# **ROYAL RANDWICK RACECOURSE NIGHT RACING**

SSD-8706: Response to  
Submissions

Prepared for  
**AUSTRALIAN TURF CLUB**  
18 February 2022

Figure 1 Site Plan

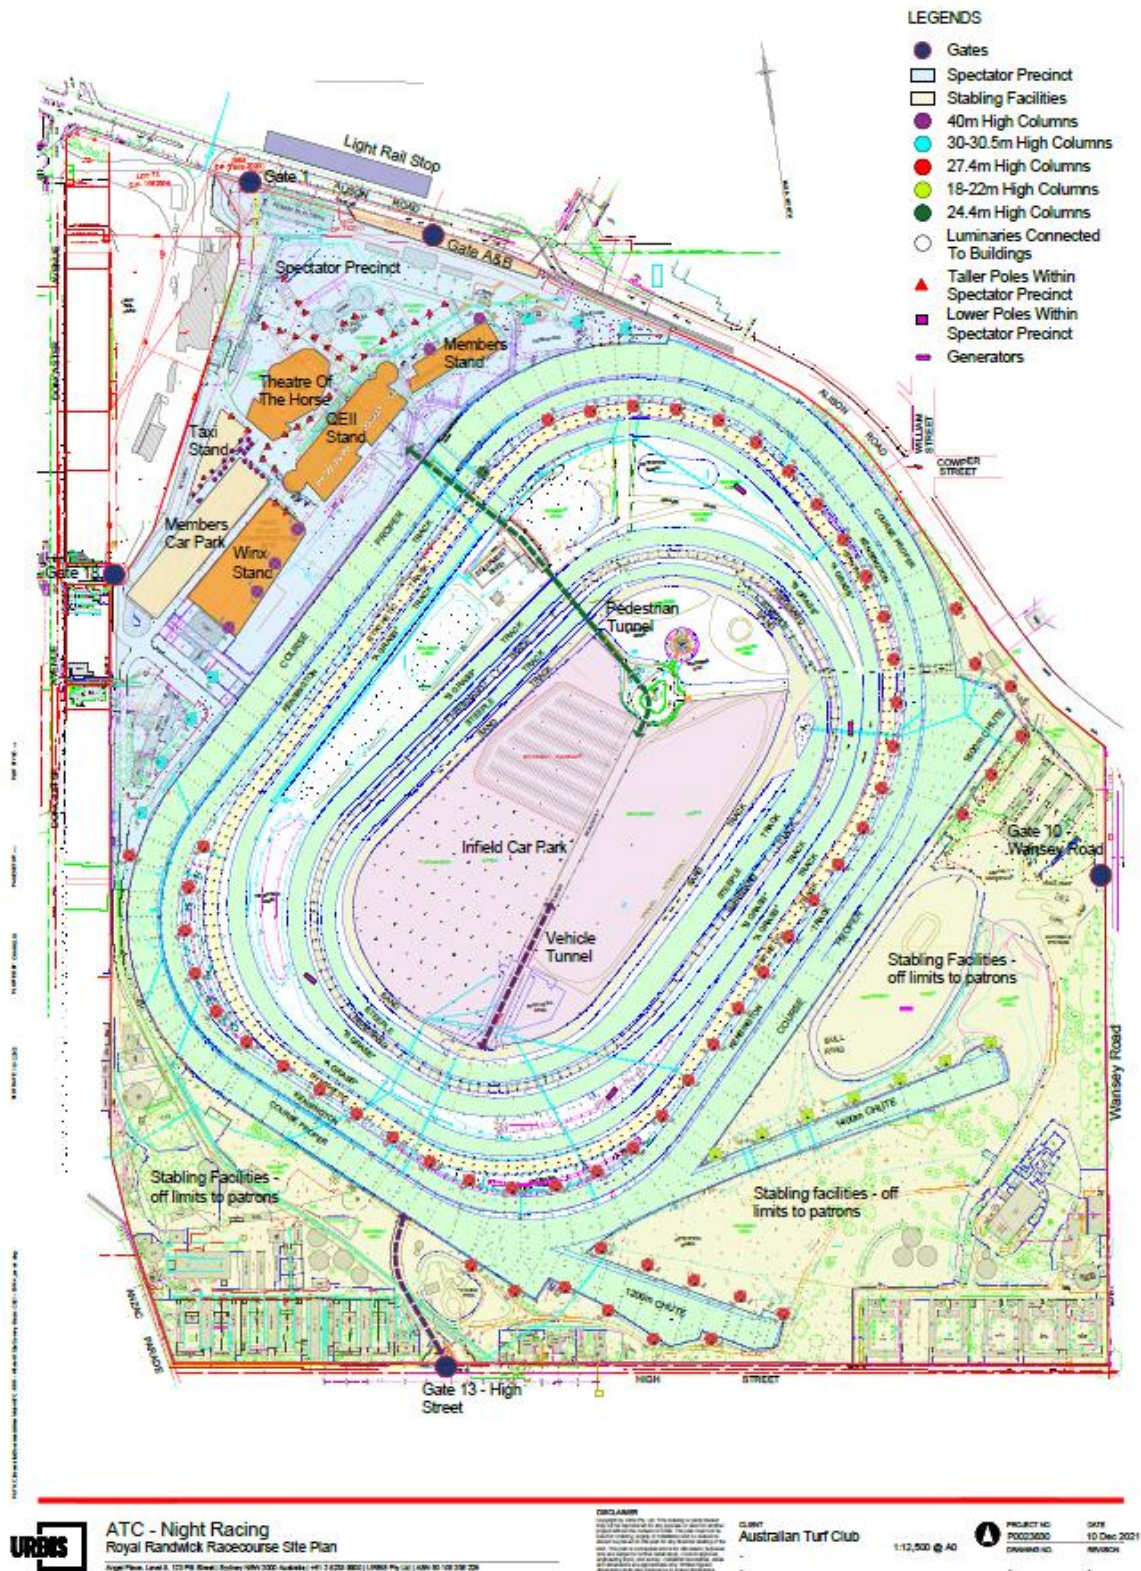
- A new Site Plan is provided as requested by DPE. The plan contains indicative heights of proposed light poles across the site. It is noted that the Spectator Precinct lighting upgrade pertains only to the replacement of lamps on existing poles. There are no proposed changes to the existing light poles in height.

- Location of proposed racetrack lighting and upgraded Spectator Precinct lighting, including height of poles for proposed racetrack lighting (refer to technical Lighting Plans provided as **Appendix F1** of the EIS). The specific design of each light pole for the proposed racetrack lighting will be finalised during detailed design stage post approval. As such, it is recommended that a condition of consent is applied that will require the dimensions and details of the light poles and associated works prior to issue of a construction certificate. This will include detailed documentation showing the precise location of each pole to satisfy mitigation measures related to the avoidance of tree protection zones and significant structures.

- It is noted that within the Site Plan, the Spectator Precinct is annotated with “Taller Poles” and “Lower Poles”. Notwithstanding, these are to indicate existing light poles that will be retained but upgraded with new lamps to improve lighting and safety after dusk. There are no new light poles proposed within the Spectator Precinct.

Figure 2 Location of the Centennial Park Grey-headed Flying-fox camp

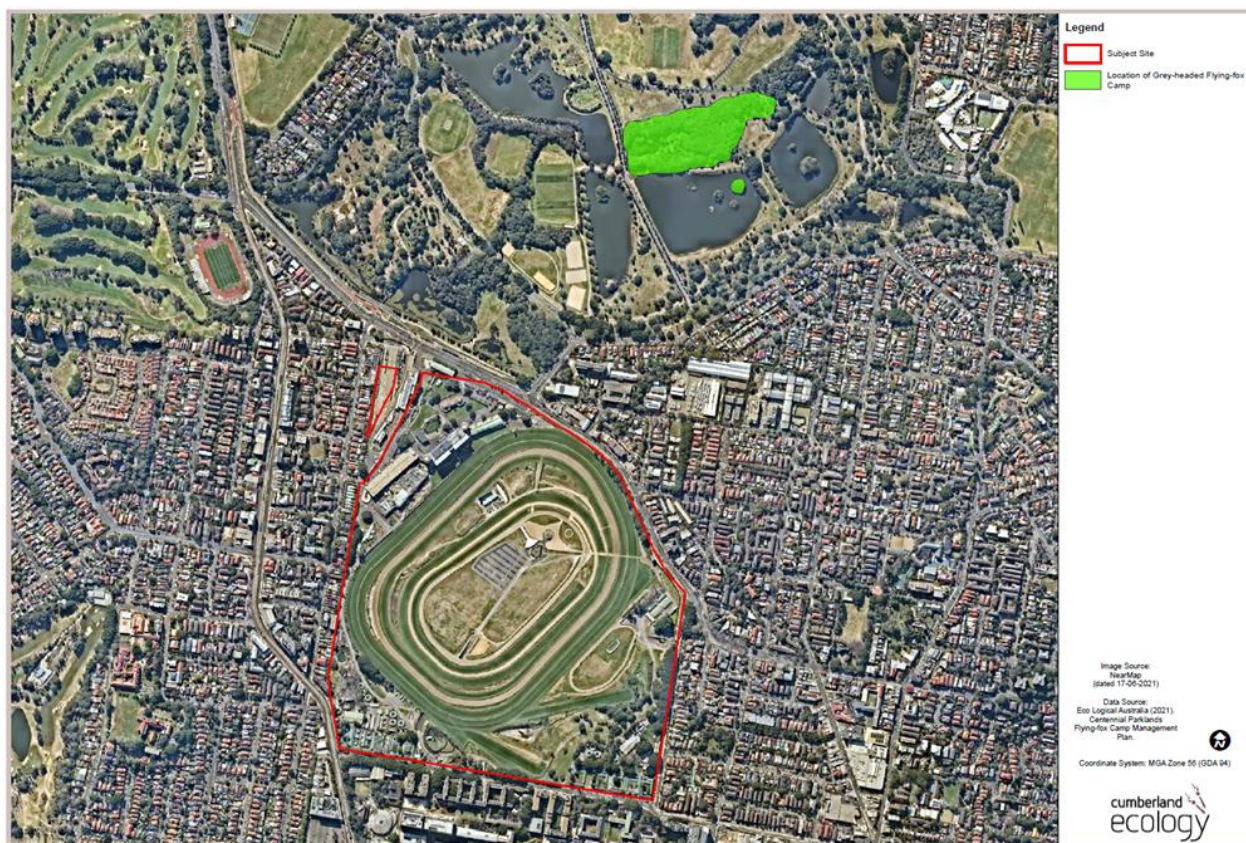
Category of Issue		Summary of Matters Raised
	Ecology	Council identified concerns that the proposed lighting may impact on the grey headed flying foxes that camp at Centennial Park.  Council also requested additional information regarding the protection of trees and requested an Arboricultural Impact Assessment.
	Heritage	Further information related to Aboriginal archaeology, European archaeology and Built heritage was requested by Council and the Heritage NSW.
Justification and evaluation of the project	Consistency of project with Government plans, policies and guidelines	Some submissions claimed the project should not be a state significant development and is not in the public interest. Another submission claims that the proposed use of the site is inconsistent with the precinct objectives, being within a dense residential area and the Kensington and Kingsford corridor.
Issues beyond the scope of the project or not relevant to the project	Animal welfare	Nine public submissions were made related to concerns of animal welfare.

Cumberland Ecology confirmed the flying-fox colony in Centennial Park is based in a camp within Lachlan's Swamp, in the southern portion of Centennial Park as shown in **Figure 2**. The camp covers an area of approximately 6.5 ha and was established in 2010. The average population count since January 2012 is approximately 21,000 individuals, with the largest number of flying-foxes recorded to date being 95,442 in February 2020. The camp is an important annual maternity roost within central Sydney.

As shown in **Figure 2**, the Centennial Park flying-fox camp is located approximately 800 m north of the subject.

Figure 4 Analysis of tree screening and visual impacts on Alison Road

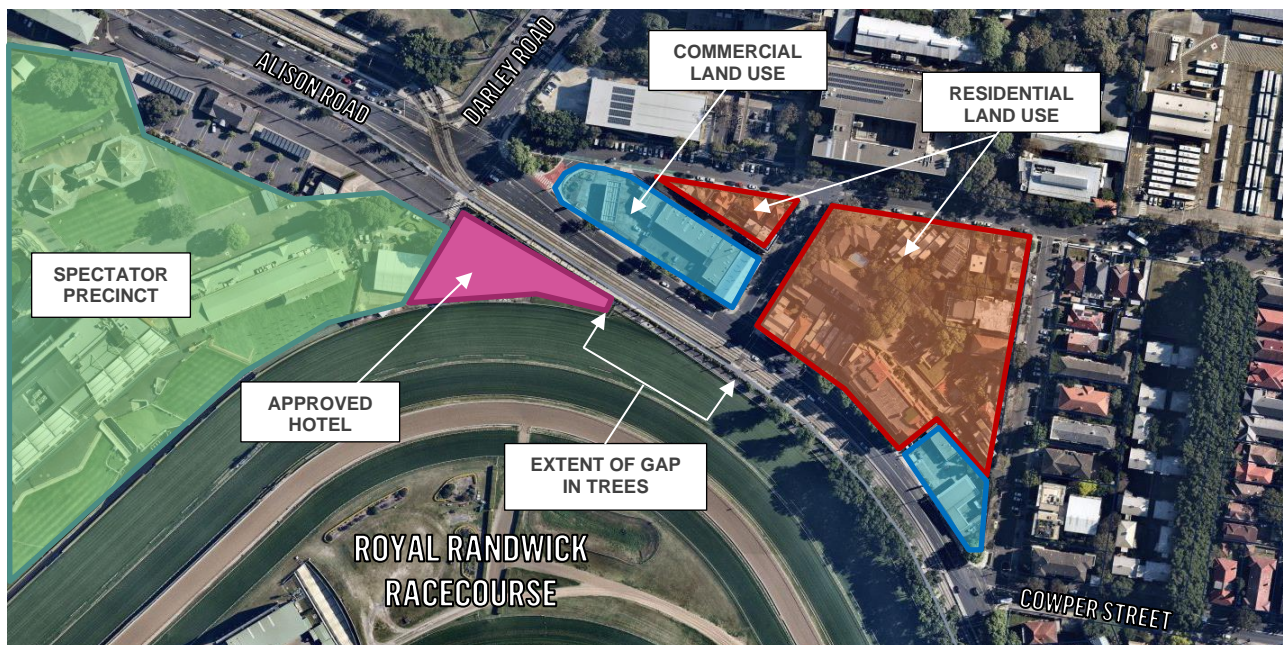
*"The Visual and Landscape Impact Report recommends new tree planting to provide screening along Allison Road and the boundary to the Racecourse adjacent to impacted residences, however no details of tree planting including exact location, species or timing of planting have been provided. Given the high degree of visibility of the proposed lighting, Council recommends details of the proposed tree planting be included in the SSD proposal to ensure appropriate mitigation of the visual impact."*

- Existing gaps in tree screening is primarily along the frontage to Alison Road between the intersection of Darley Road and Cowper Street, as shown in **Figure 3**. This gap is approximately 80 metres long when considering the construction of the future Hotel approved under SSD-5002. This gap is opposite primarily commercial land uses and so impacts on sensitive receivers is minimised. Some tree planting has already occurred to fill gaps along this frontage as shown in **Figure 4**, extracted from the Visual Impact Assessment prepared by Sturt Noble. These trees will grow over time to fill in existing gaps.

- Additional tree planting has potential to conflict with the Sydney Light Rail infrastructure along this frontage due to its proximity to the boundary of the racecourse and an existing service road inside the racecourse boundary prevents additional planting within the racecourse.

- It is noted that existing street tree planting on the northern side of Alison Road already provides additional tree screening for residential properties opposite the racecourse.
- A secondary gap in planting is identified behind the Wansey Road Light Rail stop, located on the corner of Alison Road and Wansey Road. However, tree planting has already occurred in this location and this gap will be filled once the trees have grown to maturity.
